## Plan Commission Agenda

City Hall Council Chambers  
203 S. Farwell Street, Eau Claire, WI 54701  
November 18, 2024, 6:00 PM

RE: SP-2414 – Plan Commission Site Plan Review

RE: SP-2415 – Plan Commission Site Plan Review

NORTH TRAIL AUTO  
 SITE & UTILITY PLAN  
 CITY OF EAU CLAIRE, WI

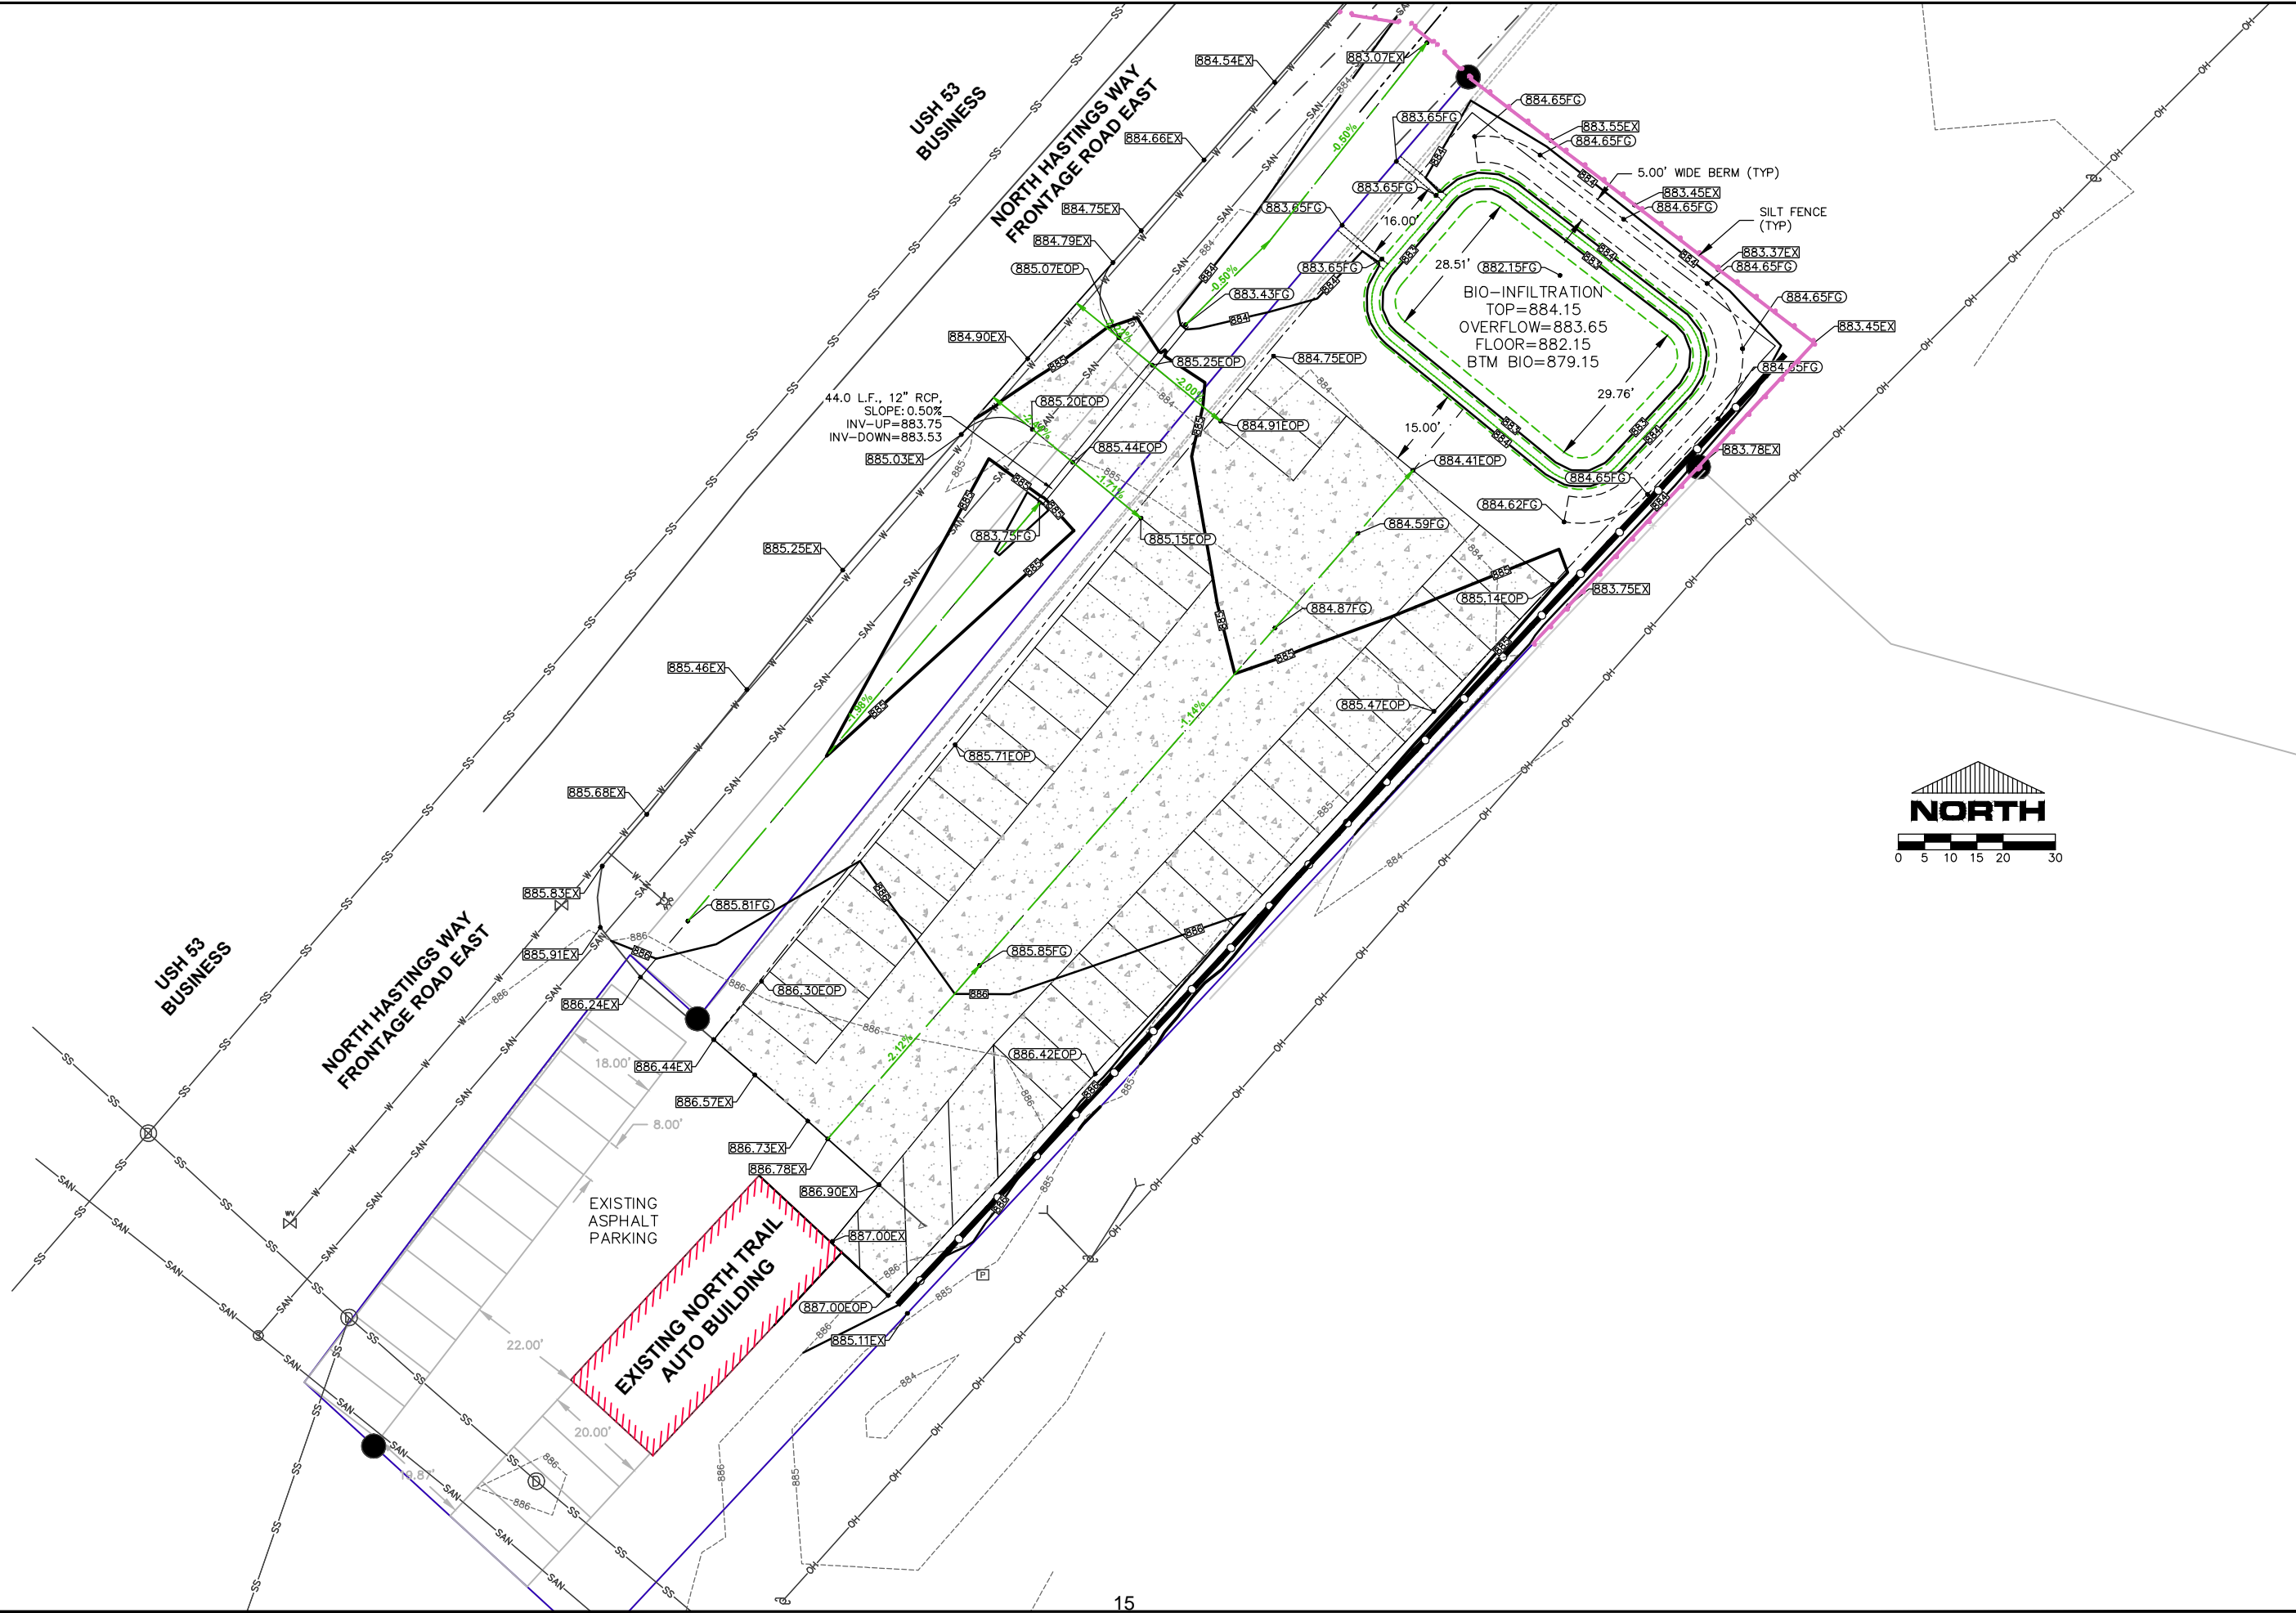
Analysis: Steve and Melissa Hallquist, owners, are requesting the approval of a site plan to expand the parking lot of their vehicle sales business located at 3101 N. Hastings Way. Attached are the narrative and site plan for the project. The proposed site plan for Northtrail Auto Sales shows the parking lot expansion to the northeast. As part of the expansion, the applicant is proposing to pave the existing gravel lot, stripe 37 new stalls, and add a new driveway at the northern section of the property. To compensate for the increase in impervious area, the applicant is proposing a stormwater retention pond on the north side to capture any new runoff.

parking lot screening. Provided in the submitted plan are detailed on the construction of a rain garden in the bioretention pond. As no other landscaping details have been provided, the applicant will need to provide a landscaping plan prior to the paving of the expansion area that contains the following details:

- Street trees at a rate of one (1) tree per 30' lineal feet of the lot frontage for the expansion.
- Plant a row of shrubs, switch grass or equivalent type at a rate of one (1) plug per two feet along the outdoor parking lot.
- An alternative design approach that incorporates a mix of both of the above to meet the intent of the ordinance, while allowing the outdoor display parking area to be seen.

Under Section 18.25.080 C, parking lots require structurally sound abutments, such as curbing or car stops, around their perimeter. Included on the site plan is fence along the eastern property line that serves as a "stop" for vehicles. To cover the rest of the site (including the existing sales area to the south that abuts the frontage road), staff recommends stops or continuous curbing along N. Hastings Way, but not along the northern end. Due to the slope of the site, staff does not recommend requiring curbing along northern line to allow for stormwater to flow into the water retention pond. If the applicant is proposing new lighting, the applicant should provide a plan prior to installation.

The Plan Commission, at its November 18, 2024 meeting, reviewed the above-referenced site plan. Conditions to be shown/satisfied on a revised site plan:

1. The parking lot should be paved by the middle of June, 2025.
2. Street trees should be installed along the expansion area at a rate of one (1) tree per 30', clumps of switch grass should be planted at a rate of 1 clump per 2' of the parking lot, or a mix of both.
3. Vehicle stops, should be provided along the side of the parking lot abutting N. Hastings Way, this can be in the form of "car stops" or continuous curbing.
4. A lighting plan shall be provided that meets the standards of the ordinance.
